Project
 Adaptation and Refurbishments

Drawing Title:
**Ground Floor Layout
 Proposed Balcony Added**

Drawing Number:
 BR-09-1013-05-1

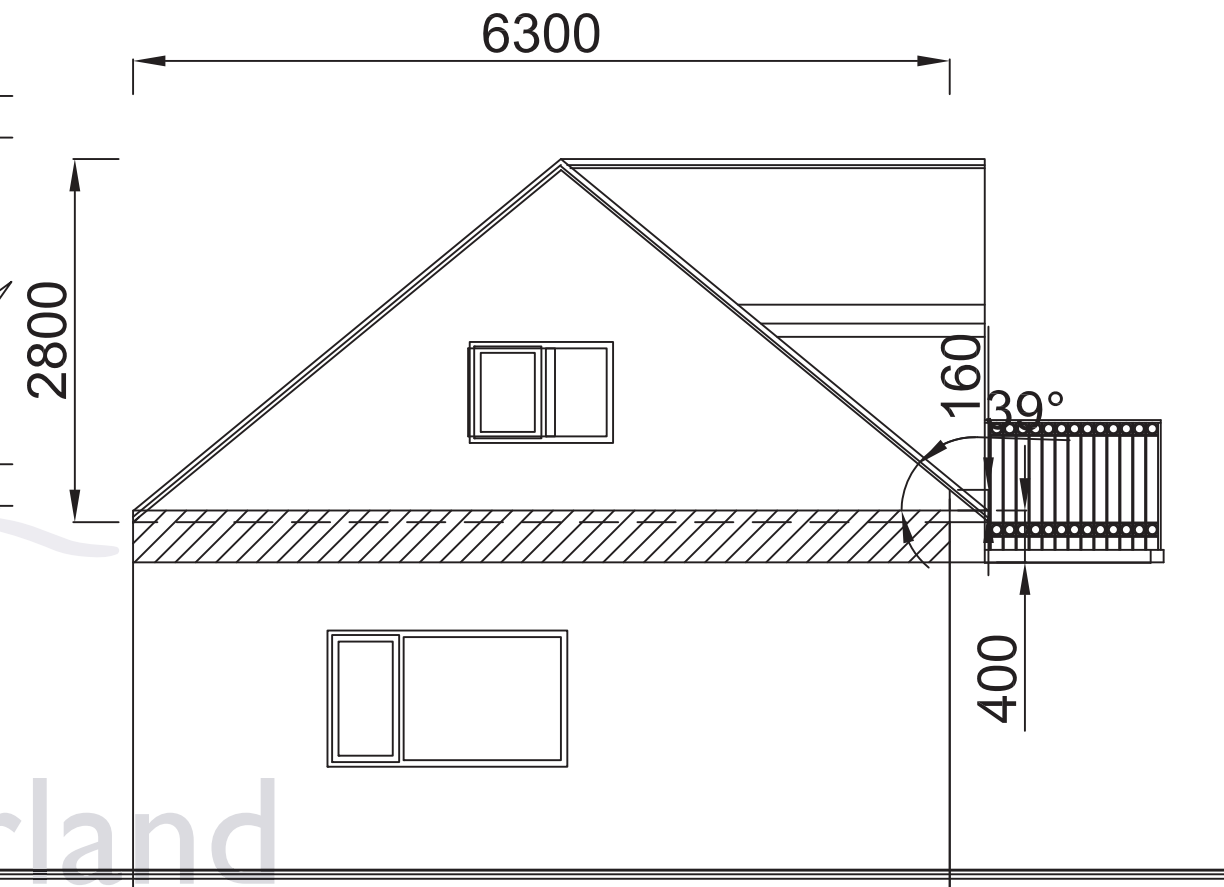
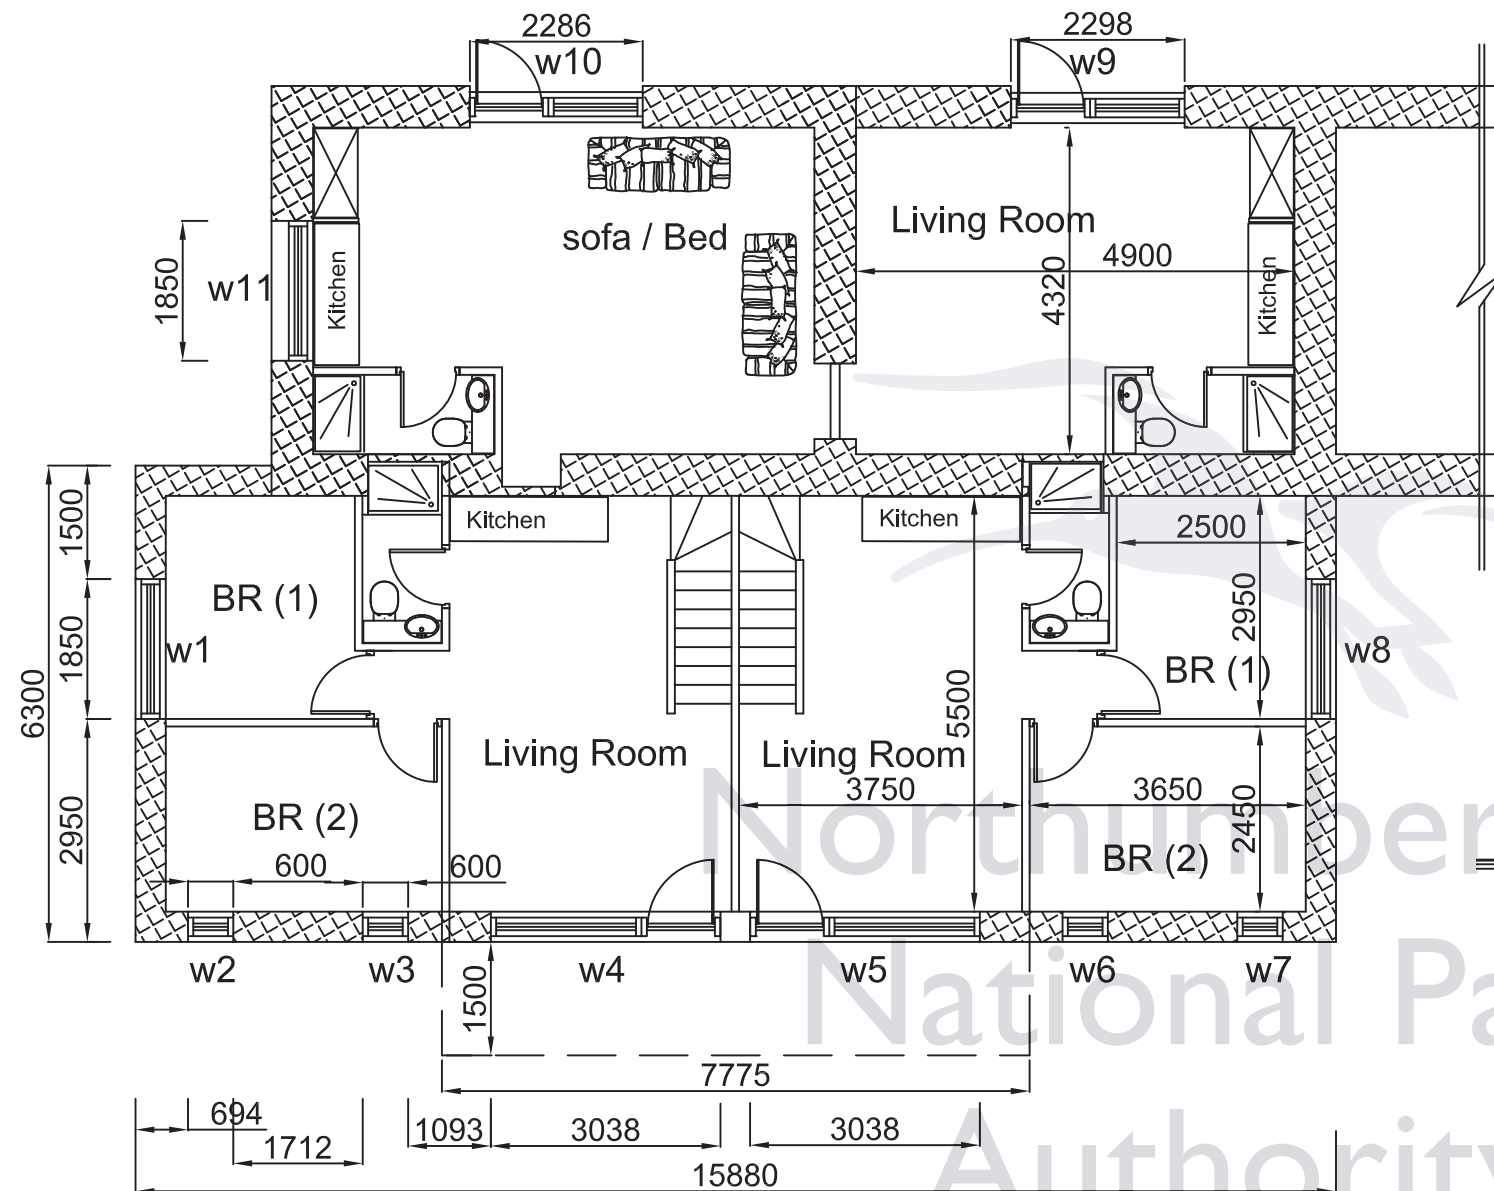
These door and windows, top should be 2250mm from existing concrete floor. (this is from concrete to underside of new Lintel)
